DNV Clothing Ltd. (Extension)

30 July 2023

Observation

Observations: Production Building-02

Cable Bracing Layout Plan: Concentric cable bracing

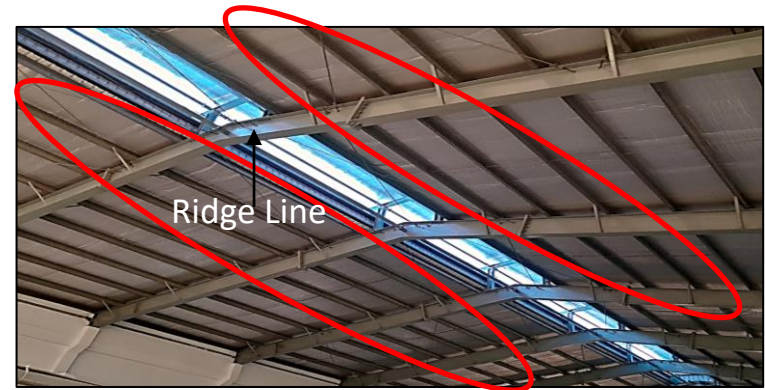
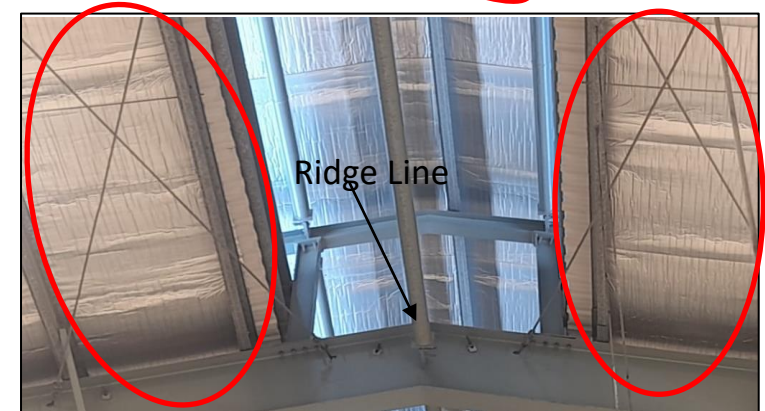
Roof cable bracing were provided. As-built drawing shows that the single line cross bracing in the longitudinal direction of the ridges. But on-site double line cross bracing observed in the all ridges. The building engineer is required to survey the whole structures and prepare accurate as-built drawings accordingly.

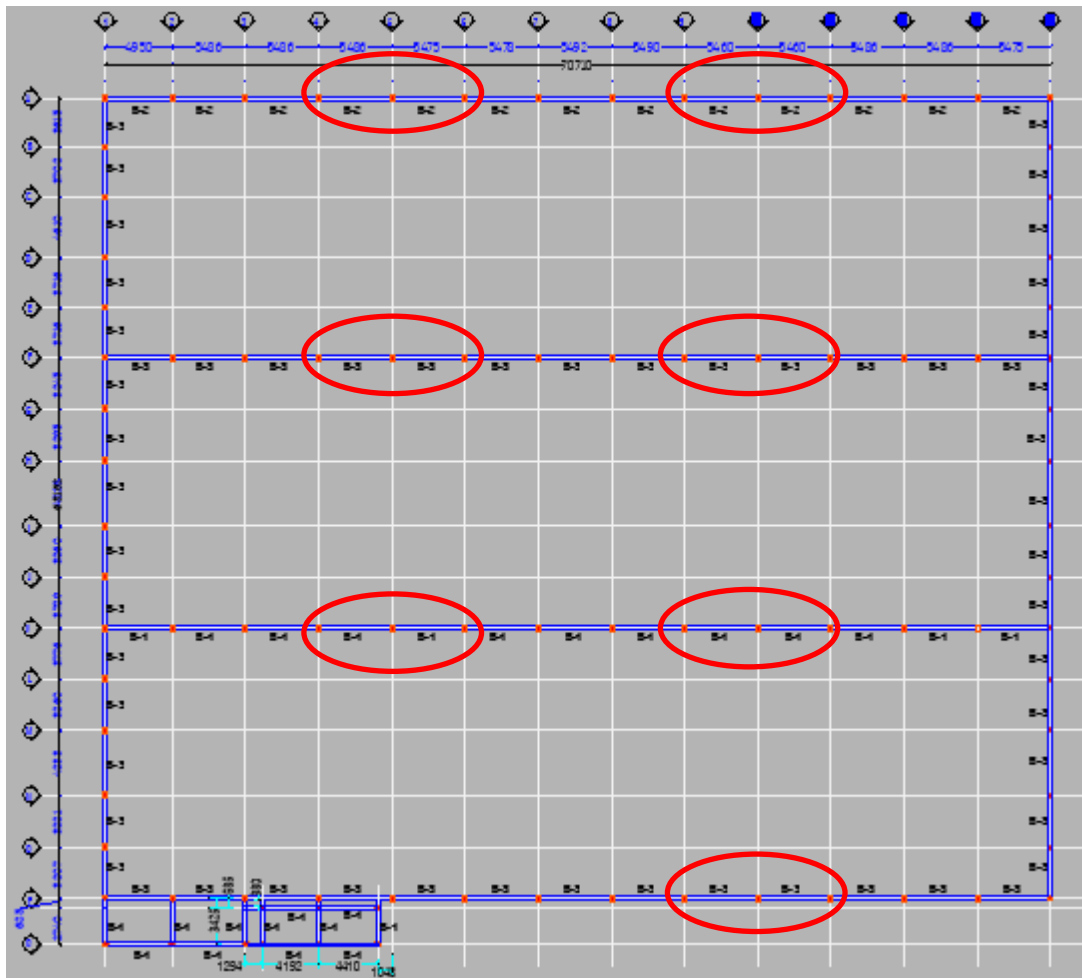
Column rebar mismatch observed during the ferro scanning. The amount of rebar in the column C1 & C2 doesn't match with the ferro scanning. The building engineer is required to ensure number and diameter of column rebar and prepare accurate schedule.

Tie Beam Layout at level +3m, +6m & +8m

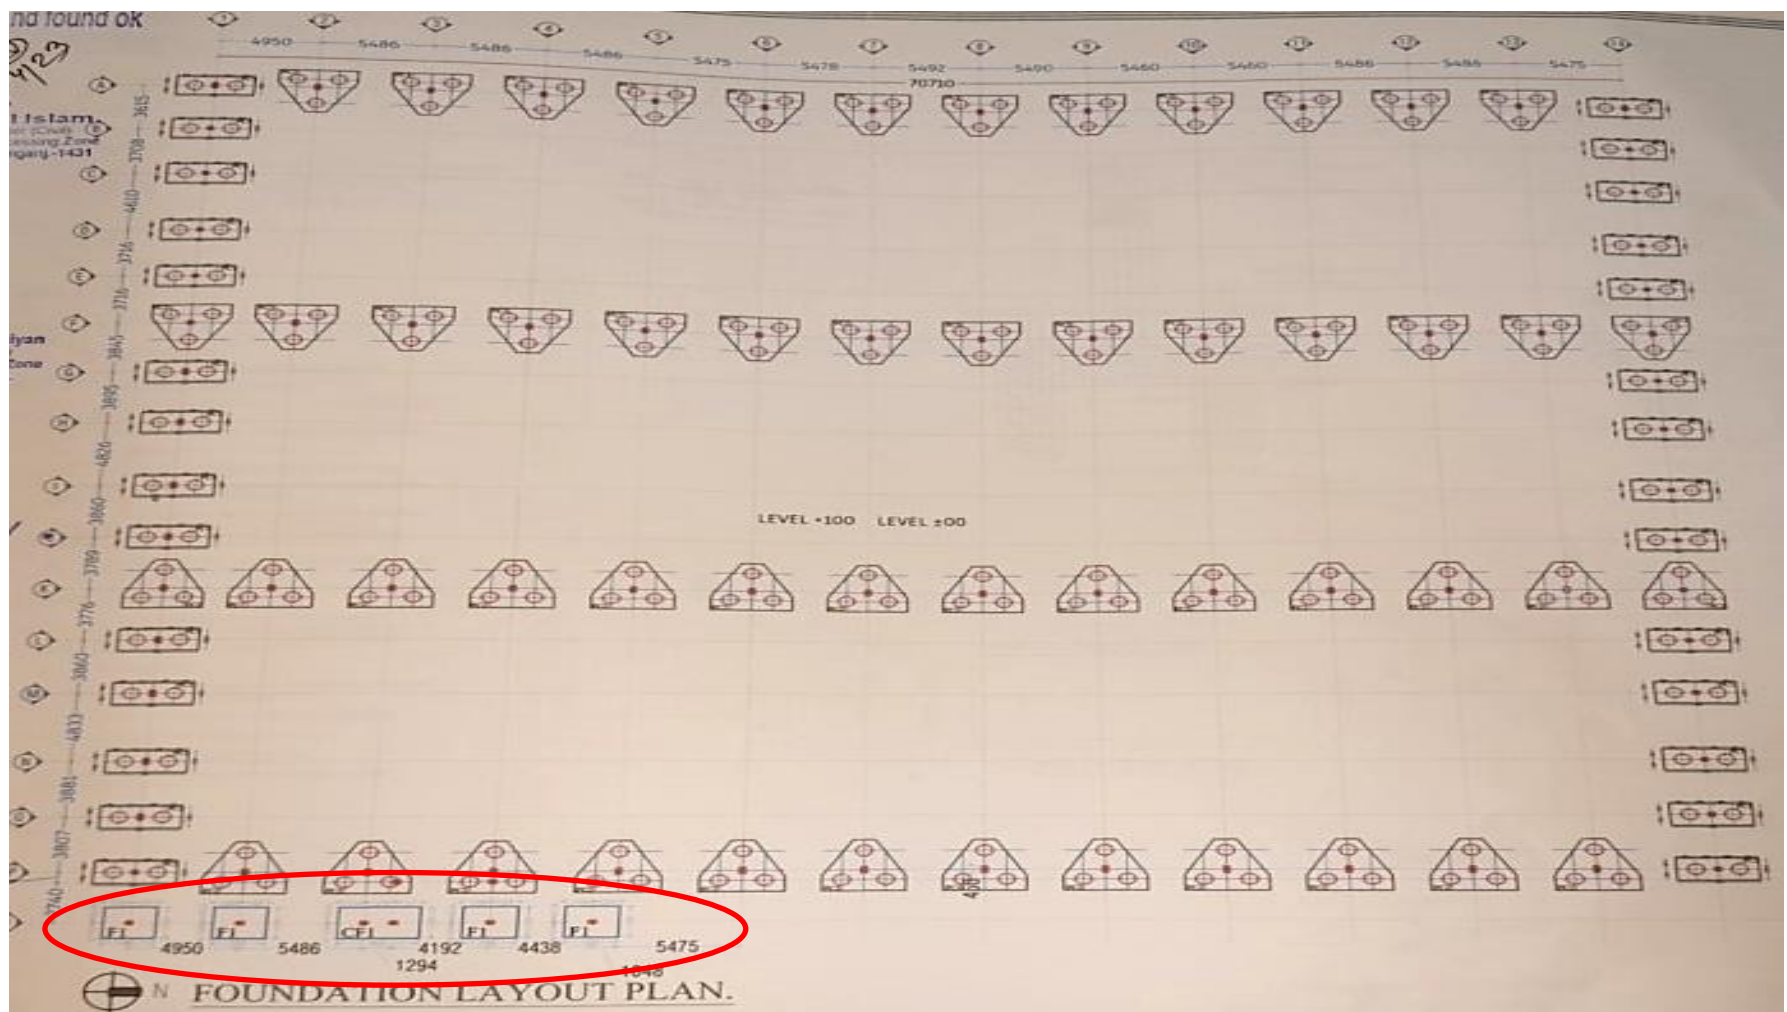
Tie Beam level offset at Grid 4-6 & 9-11 for level +3m

The building engineer is required to survey the whole structures and prepare as-built drawing reflecting the actual site condition.

Foundation Layout

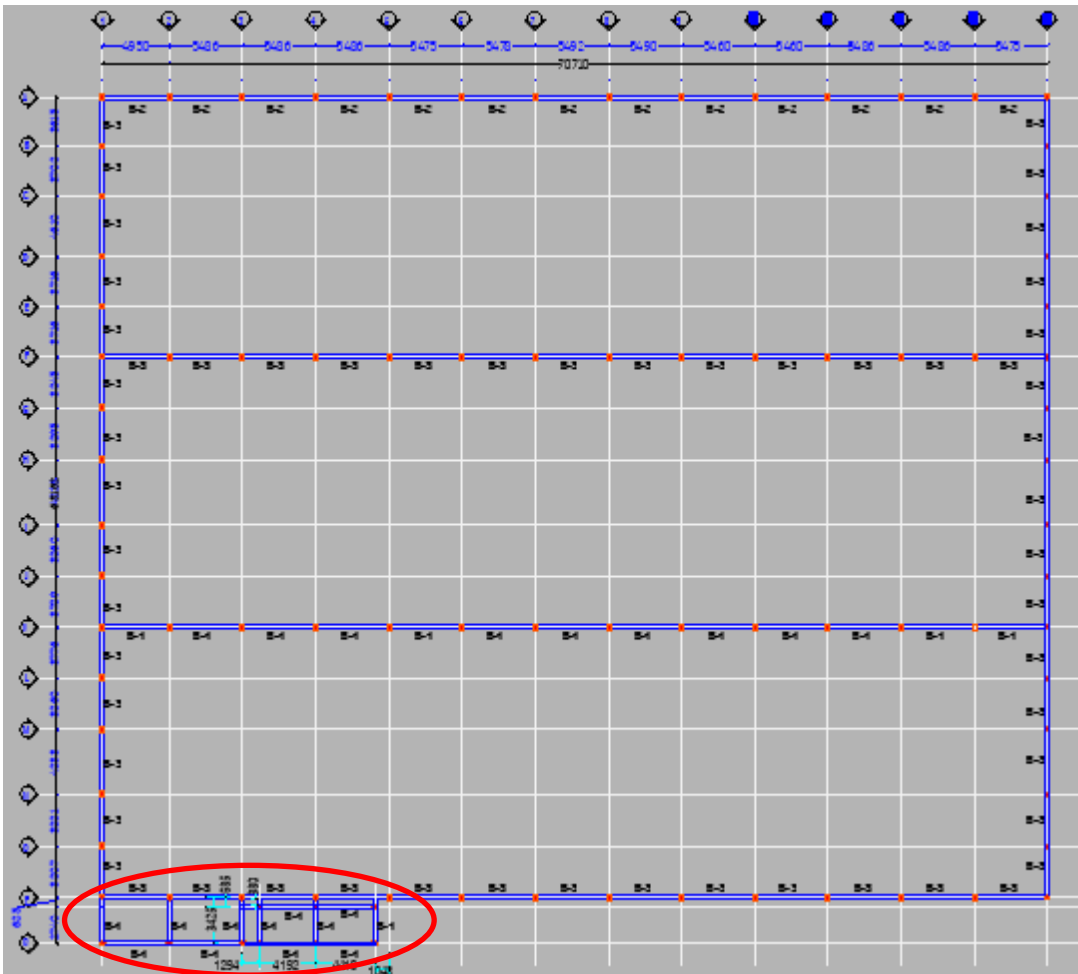
In foundation detail, only pile foundations were shown. However, no information was available regarding the shallow footing F1 & CF1. The building engineer is required to investigate the foundation system and update as-built drawing accordingly.

Beam Layout (Compression Room Roof Beam)

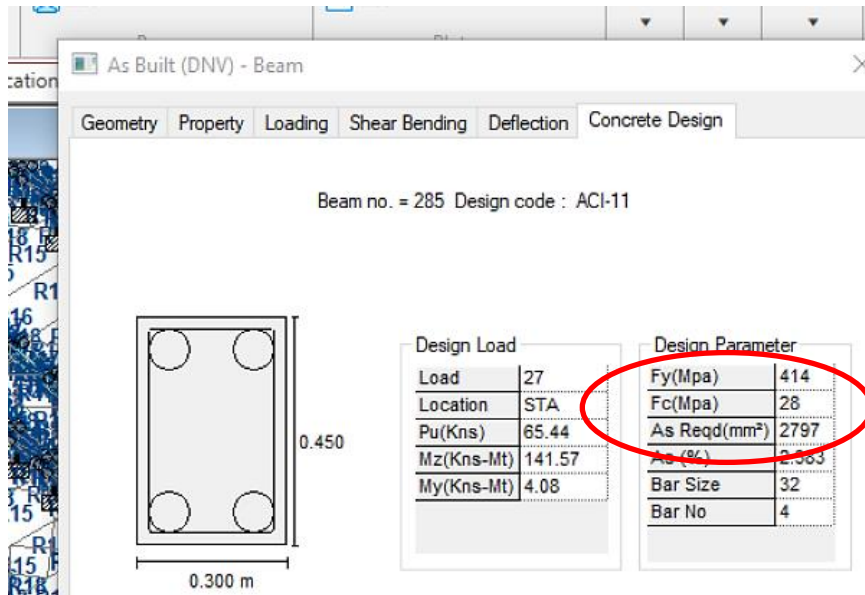
In beam layout plan, RC portion roof beam was shown. However, no information was available regarding RC roof slab. The building engineer is required to prepare accurate as-built structural drawing with slab details. Also, ensure update the aggregate information in the drawing and design.

Concrete core test report for column: Maximum strength 22.8 MPa

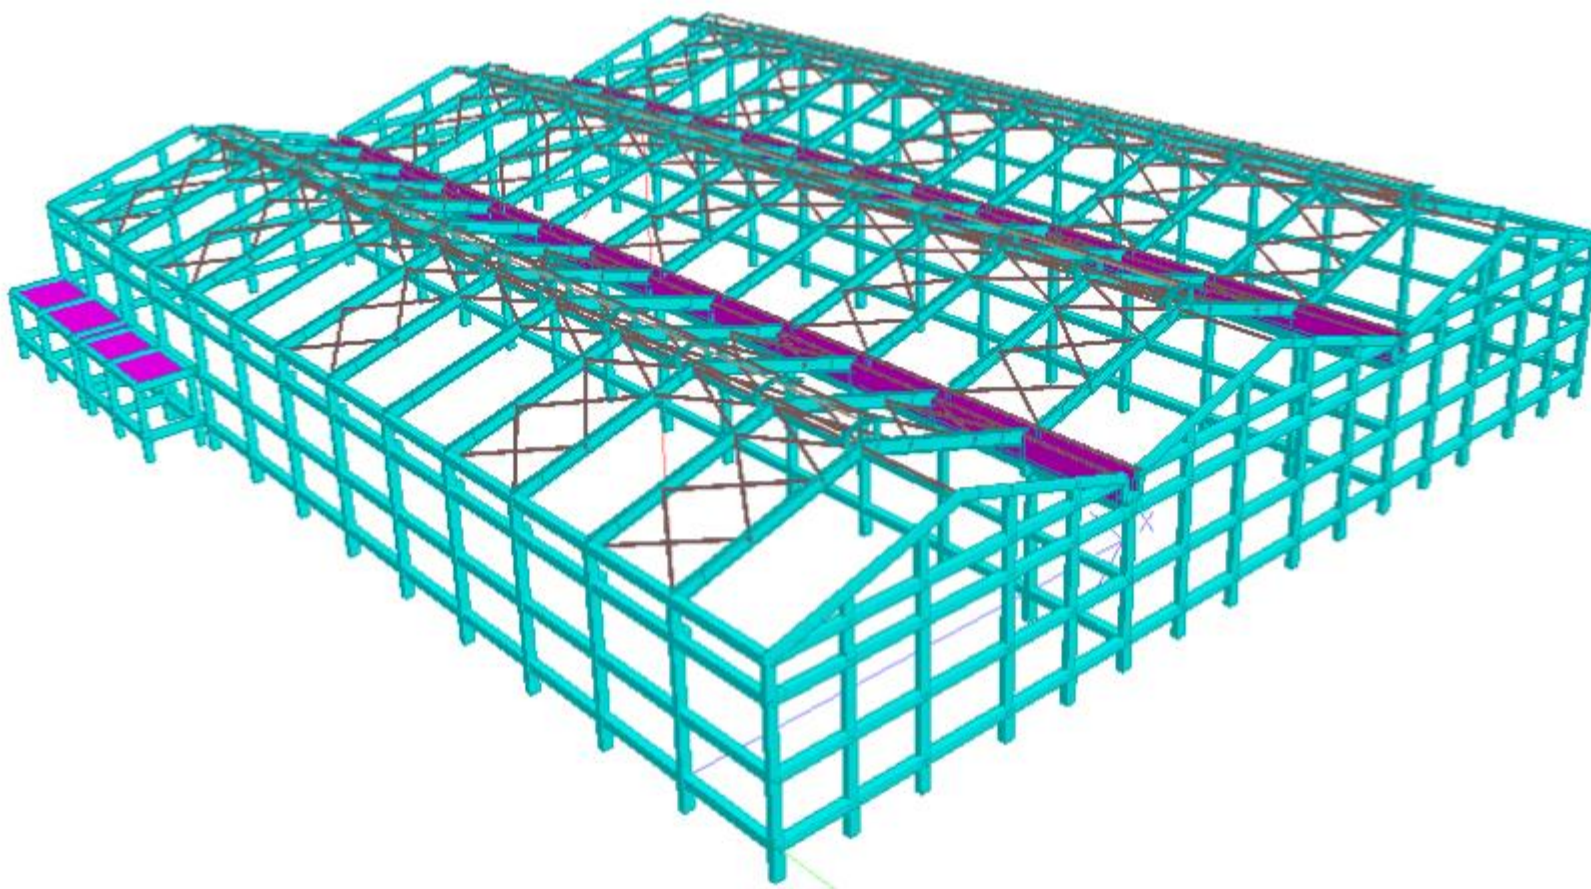
Concrete strength of column considered $f'_c = 28$ MPa without any equivalent strength calculation where core test report shows maximum $f'_c = 15.3$ MPa as per ACI 562. Building engineer is required calculate equivalent material strength and revise the design report accordingly.

At the time of inspection, 2 sets core test report found. However, sample locations were not matched in the site condition. Building engineer is required to produce a core layout and mark all the locations of the taken cores.

FEA Model

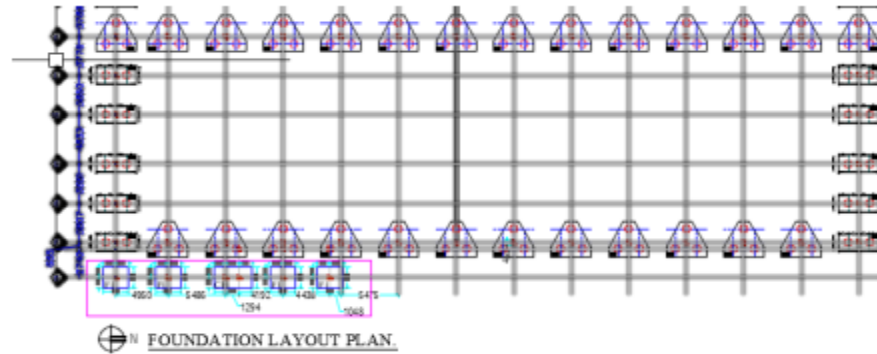
Deflection & displacement checks were not found in the report. The building engineer is required to update the design report with necessary information.
